**CITY OF NOVI CITY COUNCIL
NOVEMBER 20, 2023**

SUBJECT: Initial review of Planned Rezoning Overlay (PRO) eligibility of the request of Toll Brothers, LLC, for Elm Creek, JZ22-28, to rezone from Office Service Technology (OST) and Low-Rise Multiple Family (RM-1) to Low-Rise Multiple Family (RM-1) on land located on the west side of Meadowbrook Road, south of Twelve Mile Road in Section 14. The applicant is proposing to utilize the Planned Rezoning Overlay option to rezone and develop a 134-unit multiple-family townhome development on approximately 37 acres of land. Under the new PRO Ordinance, this initial review by City Council is an opportunity to review and comment on the eligibility of the proposal.

PLANNING REVIEW

Revised PRO Concept Plan: Consideration of Eligibility
Rezoning Request from OST Office Service Technology to Low-Density Multiple Family RM-1 with a Planned Rezoning Overlay

SHEET **4**

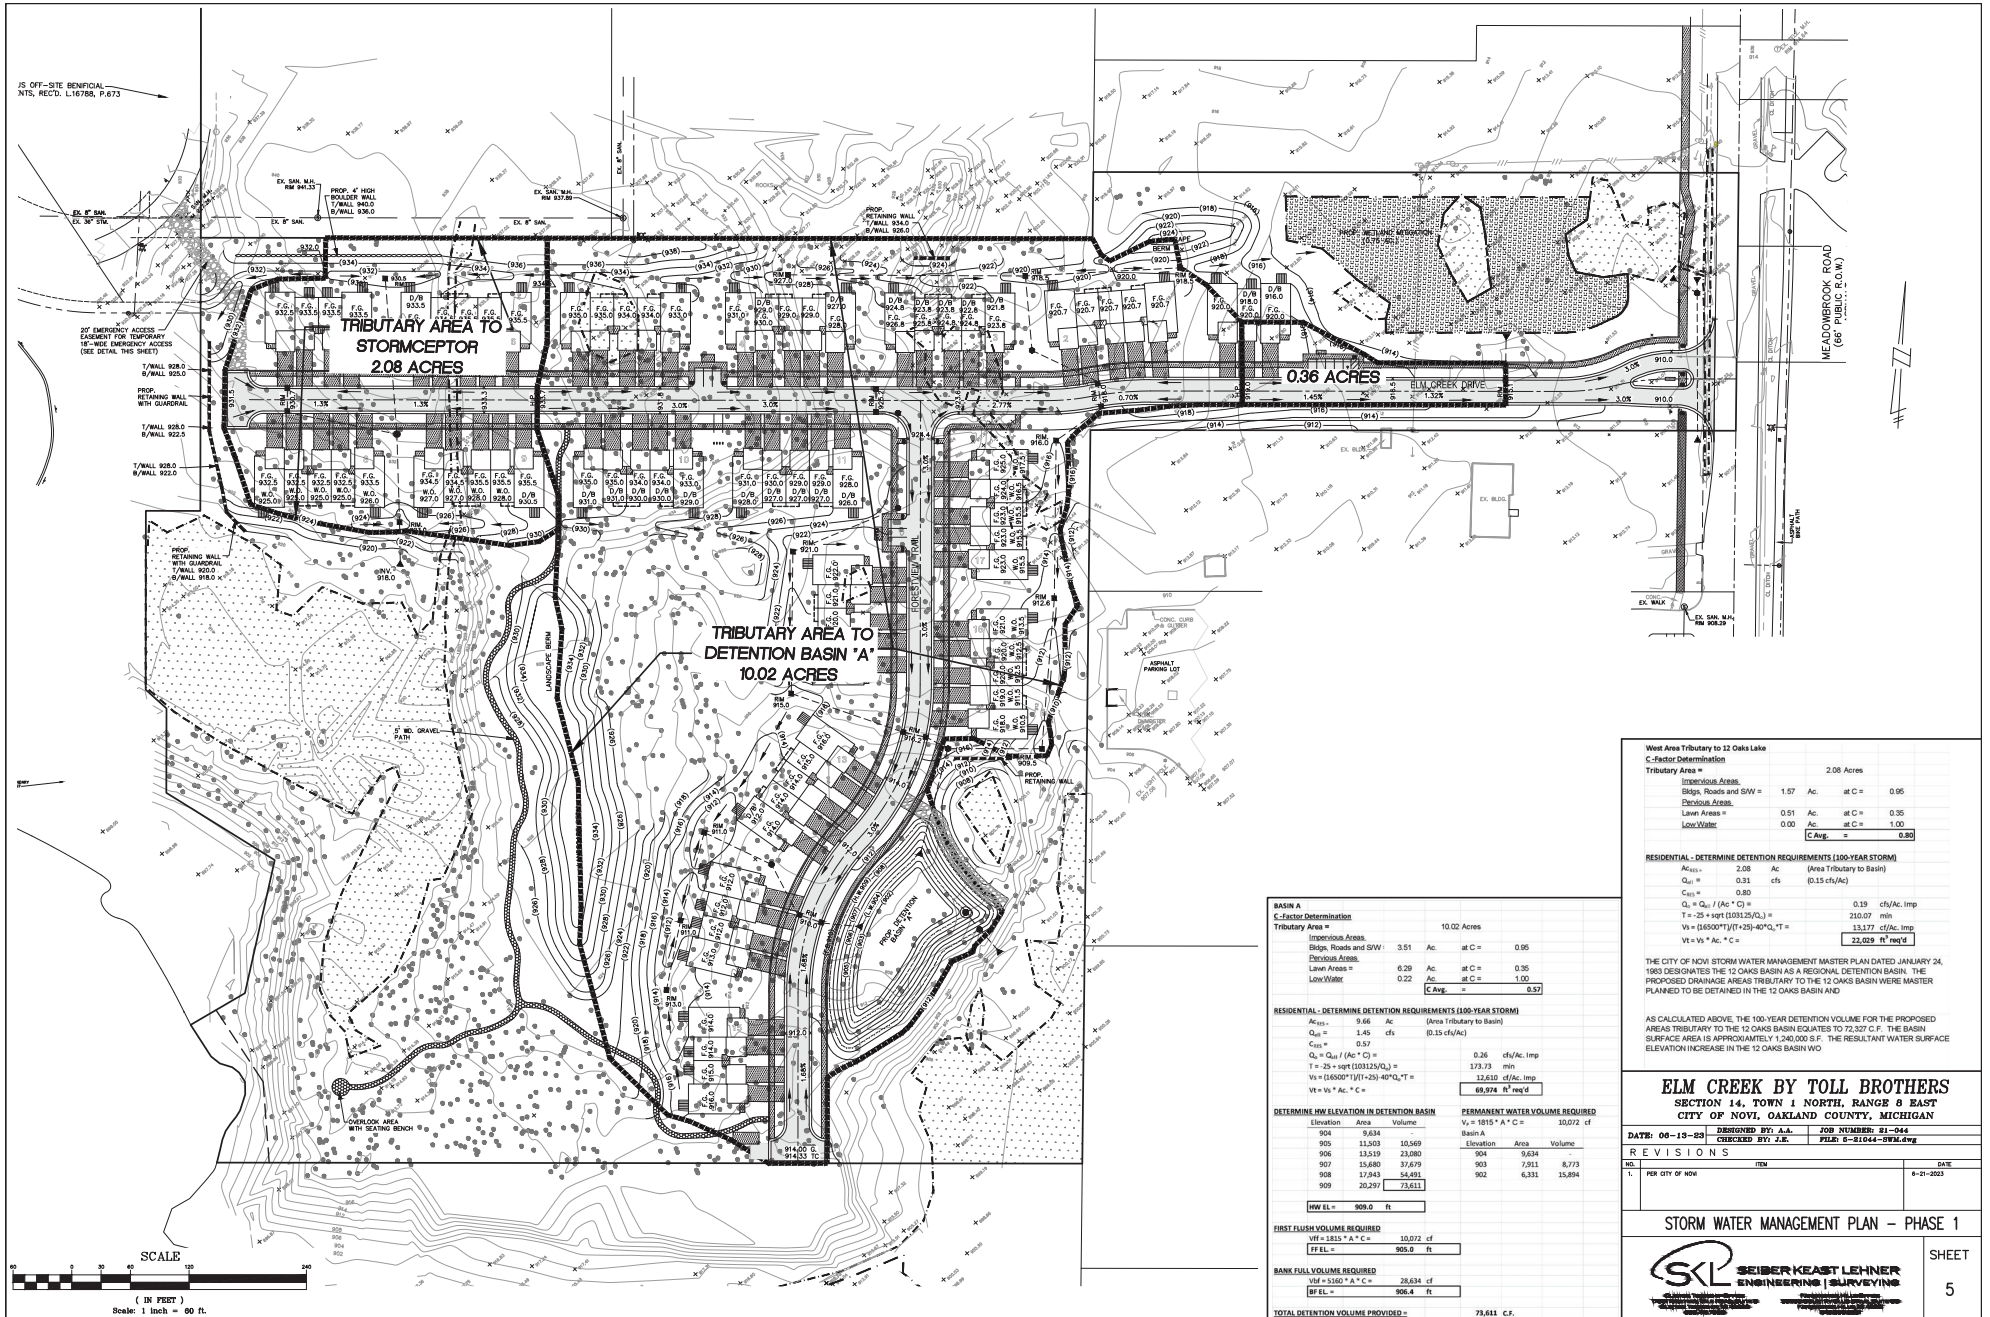
38. The contour lines on plan Sheet 4 shows different elevations than Sheet 5 (south side of the property). It appears Sheet 4 is correct.
39. Provide at least 3-foot of buffer distance between the sidewalk and any fixed objects, including hydrants and irrigation backflow devices. Include a note on the plan where the 3-foot separation cannot be provided.
